## **PLANNING AND ZONING COMMISSION (PZC)**

**Project Title:** NE Quad PUD Sub-Area: **Section 2** Minimum Setback Change

1. Old: "Rear yard setback shall be 25% of lot depth or a maximum of 50'."
2. New: "Rear yard setback shall be a minimum of 20'."

## NE Quad PUD Sub-Area Map

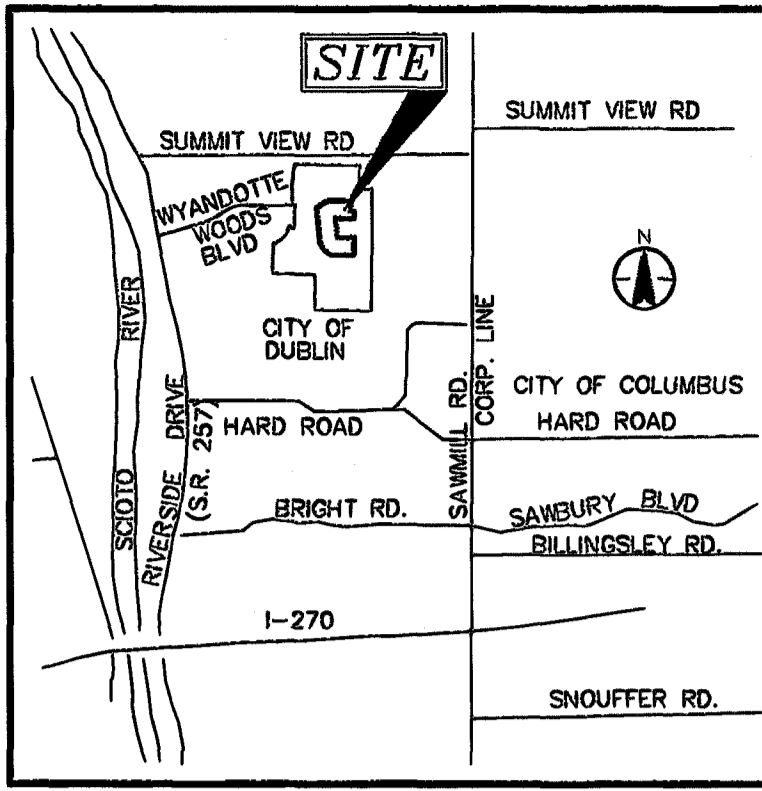
I am writing to you as the newly elected Wyandotte Woods II Homeowners Association President to request a change to the current setback requirements in the NE Quad Planned Unit Development (PUD) for section 2 of Wyandotte Woods, per the Sub-Area Map that is attached to this packet. To provide background on the request, the home developer in the community, Trinity Homes/Homewood Corporation developed Wyandotte Woods in many sections. The initial lots were materially larger, and as the community was being developed, the lots became progressively smaller, with the smallest lot being 0.22 acres, or 127' in depth. For each additional section that was developed, Trinity Homes/Homewood Corporation would copy the prior PUD that had the exact same development standards, despite the lot depths materially shrinking in the latter phases of development.

To remedy this design flaw in the PUD for section 2 of Wyandotte Woods, we are requesting to modify the rear yard setback requirement to 20' to allow homeowners to build reasonably sized

# WYANDOTTE WOODS SECTION 10 FINAL PLAT

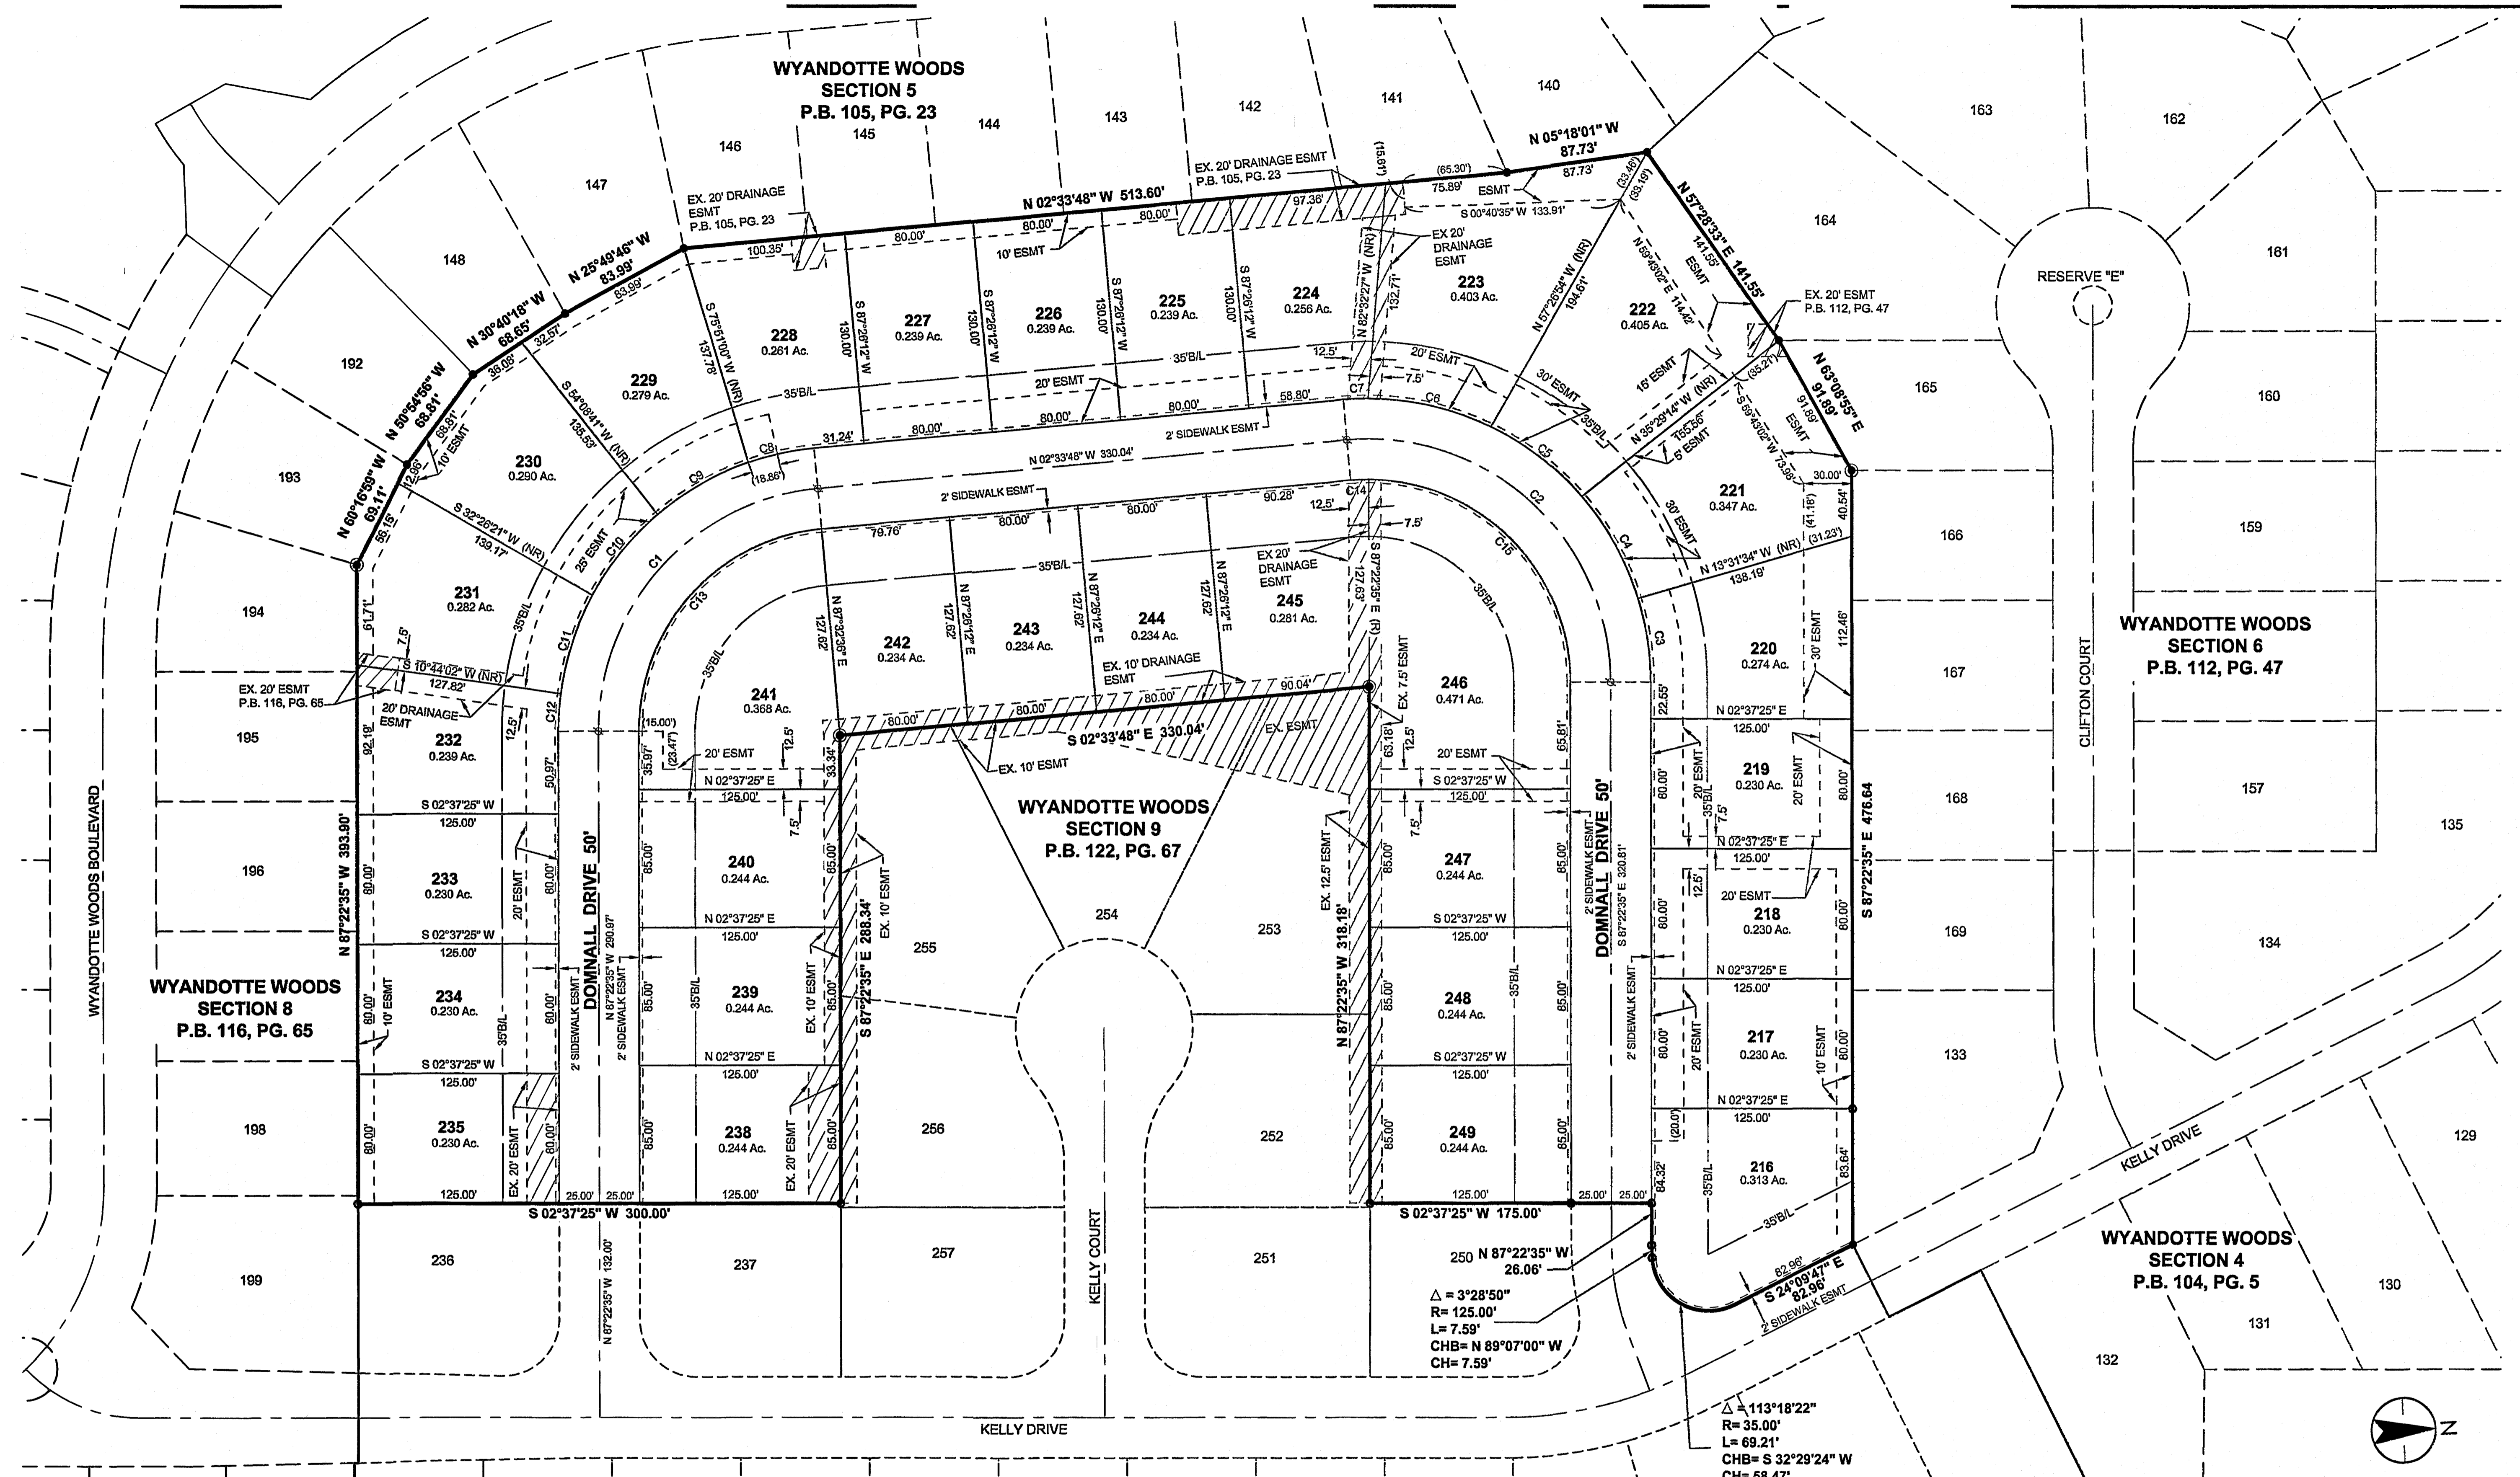
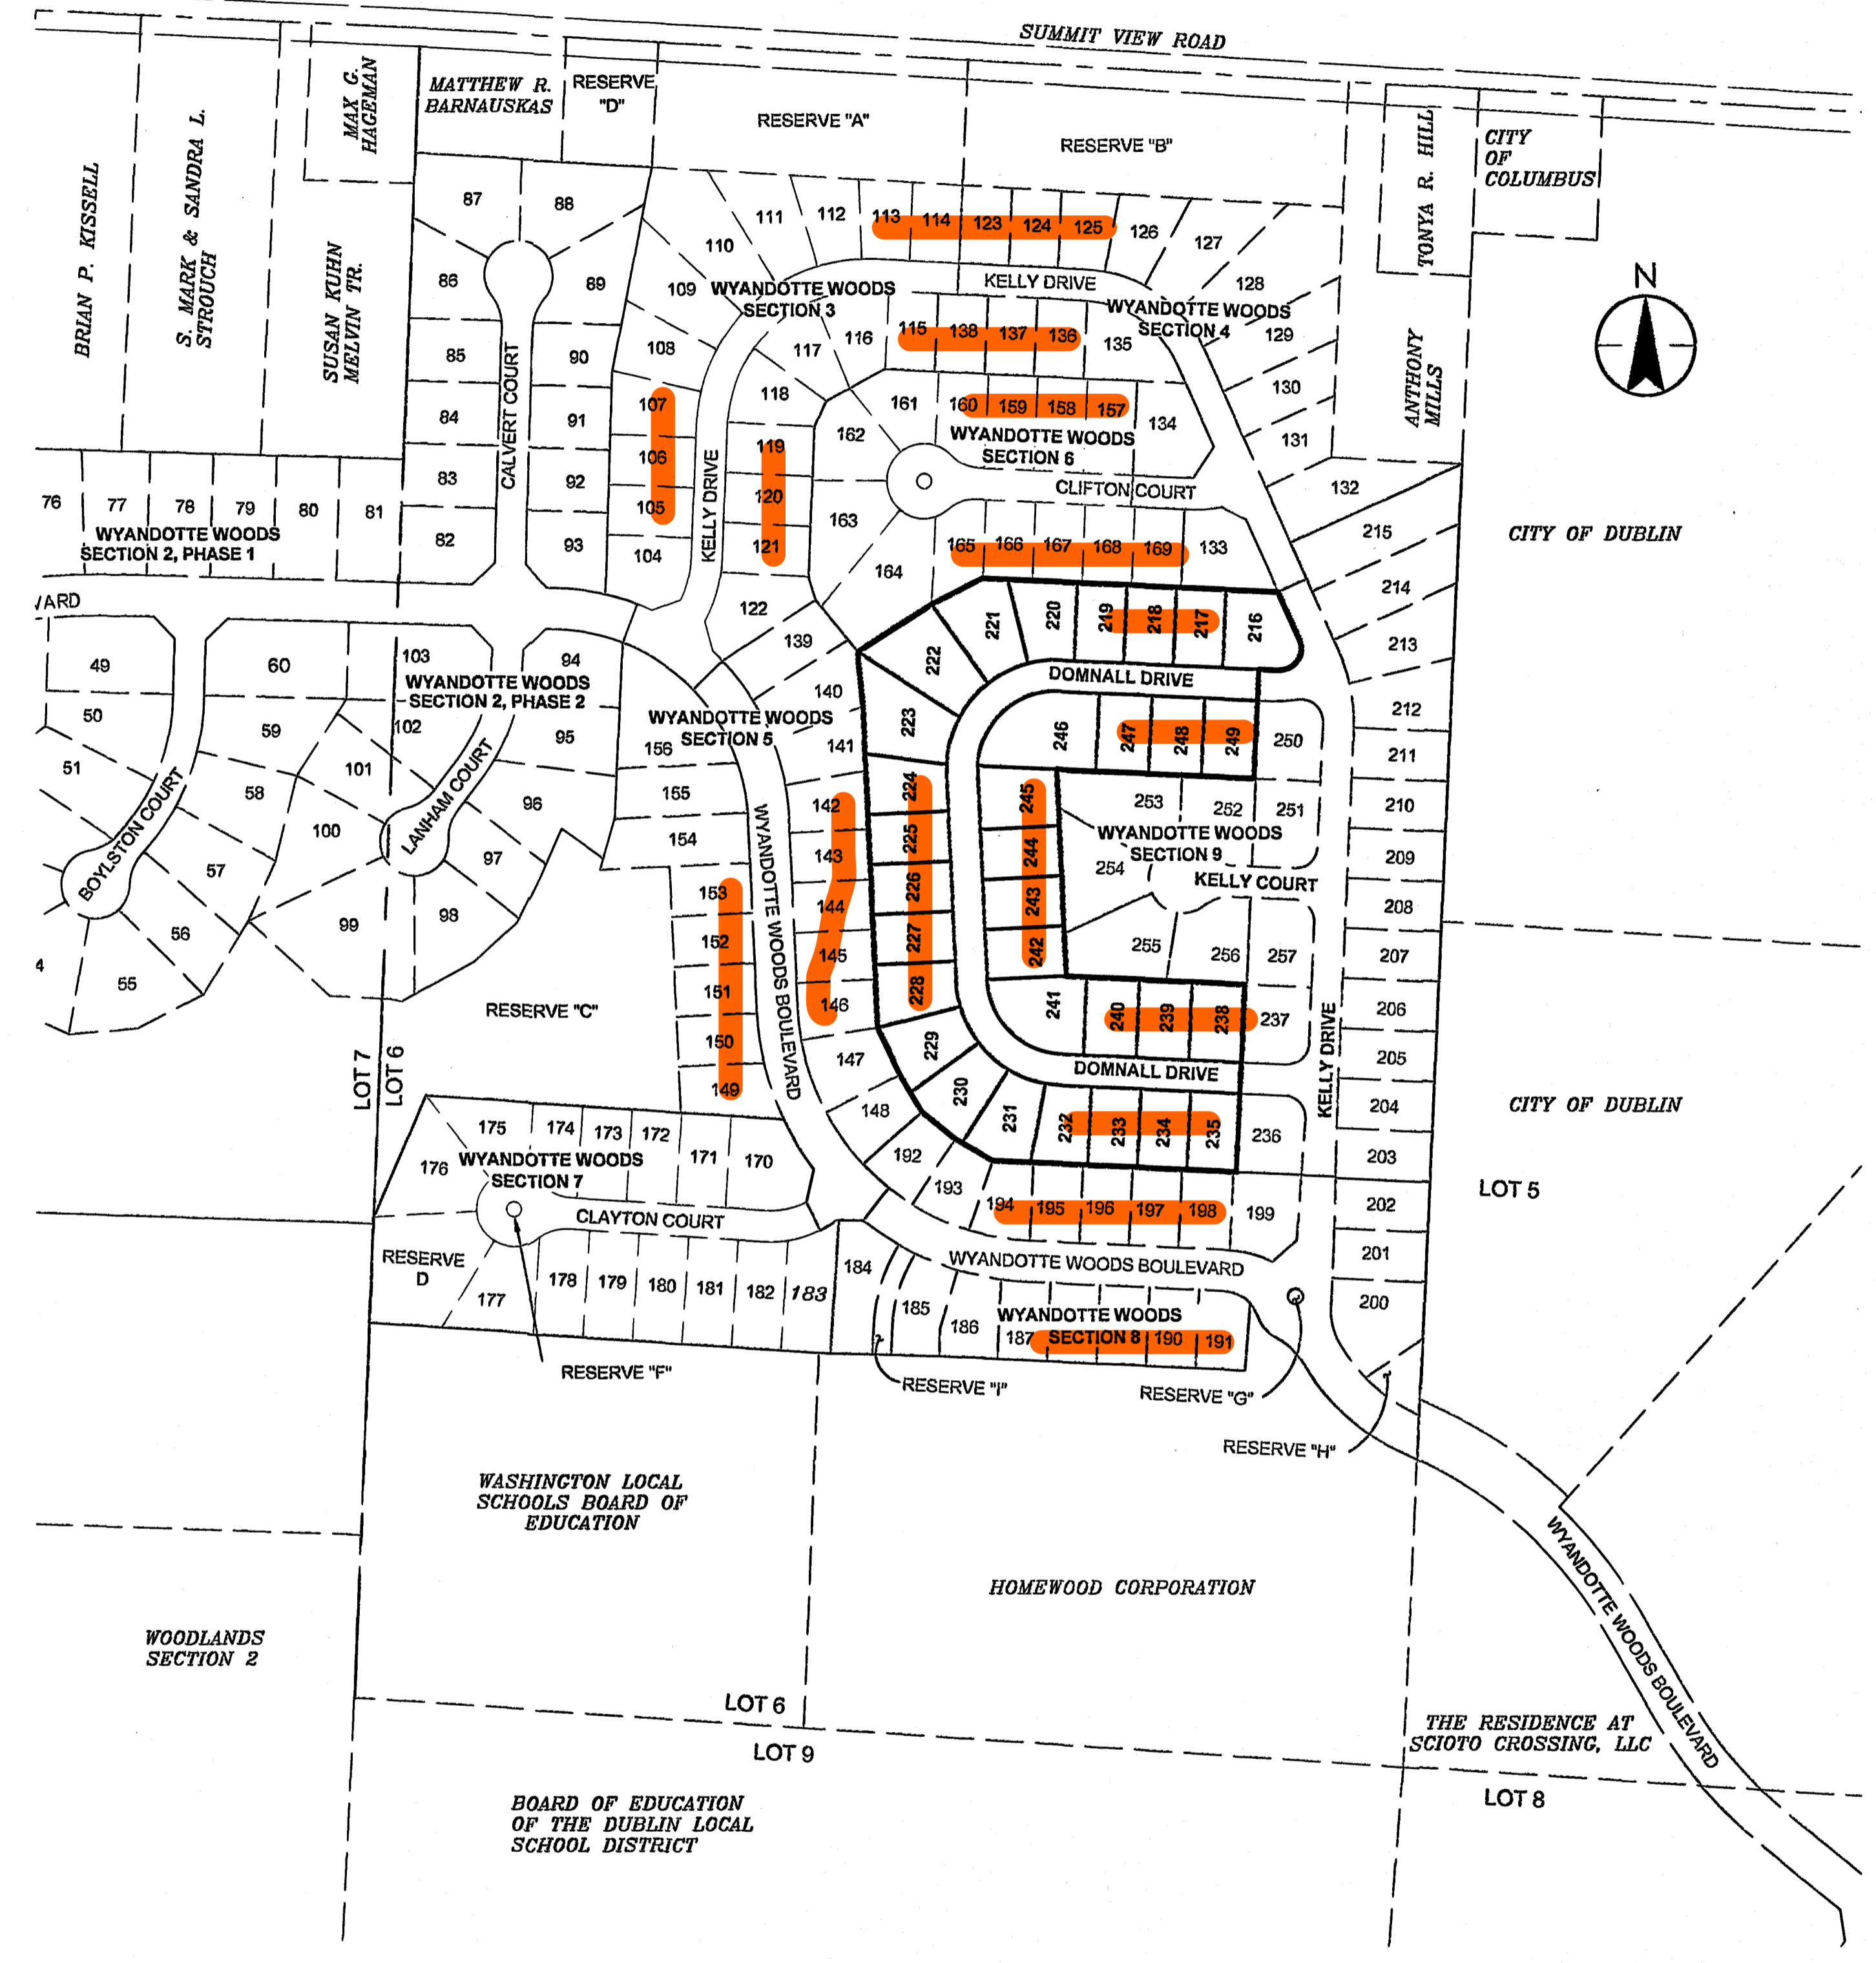
highlighted lots currently cannot build a 15' patio with the setback requirements at 25% of lot depth (Currently a minimum of 32' based on smallest lot depth of 127')
